Responses to Comments

on the Additional Investigation Results

National Aeronautics and Space Administration, Jet Propulsion Laboratory, Pasadena, California

December 2008

Figure A1-4. Capture zones in JPL Model Layer 4 - backward particle tracking from Monk Hill Subarea production wells.

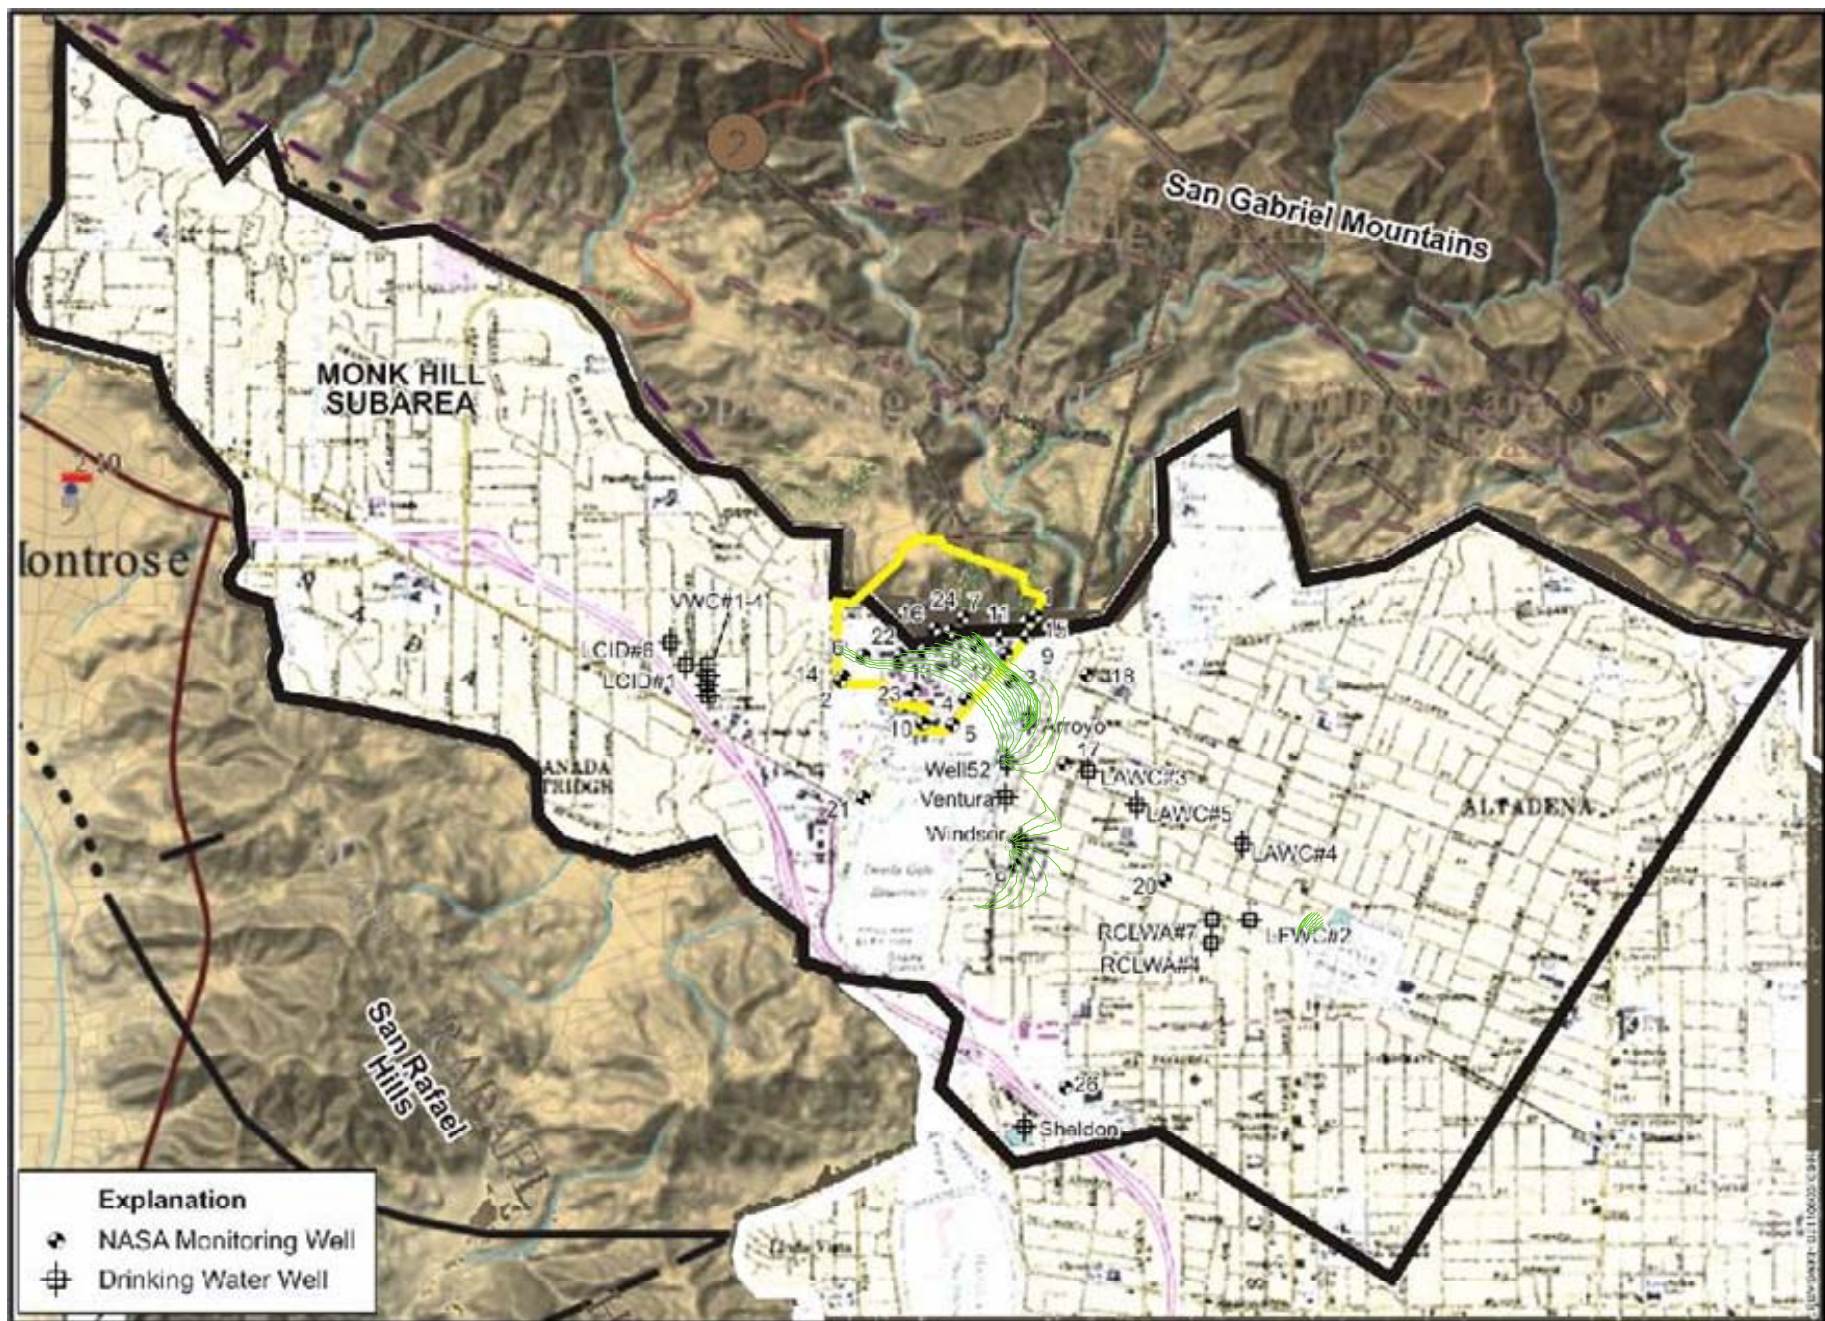
EPA Comment No. 3 – The RBMB model is a two layer regional model, and the JPL model is a more localized site model consisting of four layers. Figures 2, 3, and 4 show particle tracking simulation results. Considering the existence of the vertical hydraulic gradient, the particle paths would look different for each layer. The composite paths shown in Figures 2, 3, and 4 are then not sufficient to describe the three-dimensional nature of the particle paths. Please show the information for each layer rather than as a composite. Please show the particle paths in cross-section as well as forward paths originating at JPL.

As requested, Figures A1-1, A1-2, A1-3, and A1-4 have been prepared to show capture zones in each of the four zones defined in the JPL Modeling Report. A lithologic cross section representing a transect from the JPL source area to the downgradient production wells is shown in Figure A1-5. These figures show that the production wells provide vertical and horizontal containment of chemicals originating from JPL.

Figure A3-2. The distribution of calcium and sodium in Type 1 and Type 3 groundwaters in the Monk Hill Subarea substantiate the ion exchange reaction that results in Type 3 water.

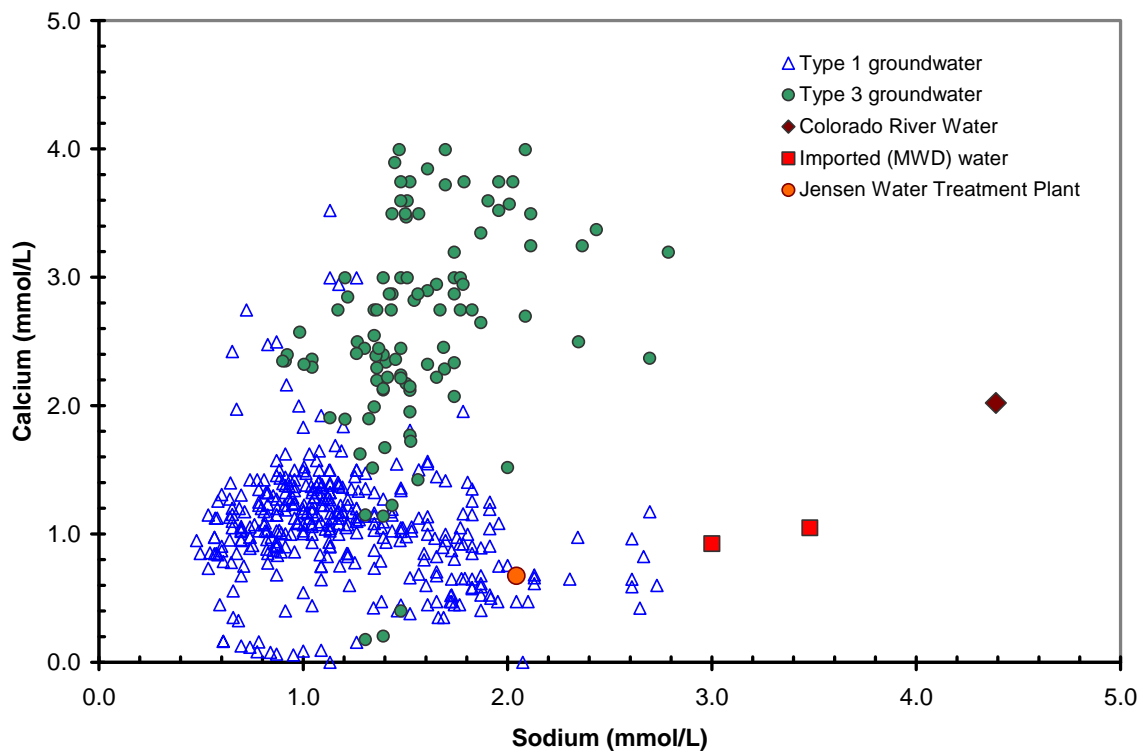
Geoscience Comment No. 2 – The NASA technical memorandum claims of imported water impacts on ambient water quality are not supported by data.

Concentrations of calcium and sodium in Monk Hill Subarea groundwater are shown graphically in Figure A3-2, where it can be seen that Type 3 groundwater typically has much higher calcium concentrations than Type 1 groundwater. This figure also shows that calcium concentrations in Type 3 groundwater are higher than those of either imported MWD water or the Colorado River water. Another difference in water quality is that imported MWD and Colorado River water have higher sodium content than either Type 1 or Type 3 groundwater (Figure A3-2). A mass action equation describing the ion exchange is shown by Eq. 1
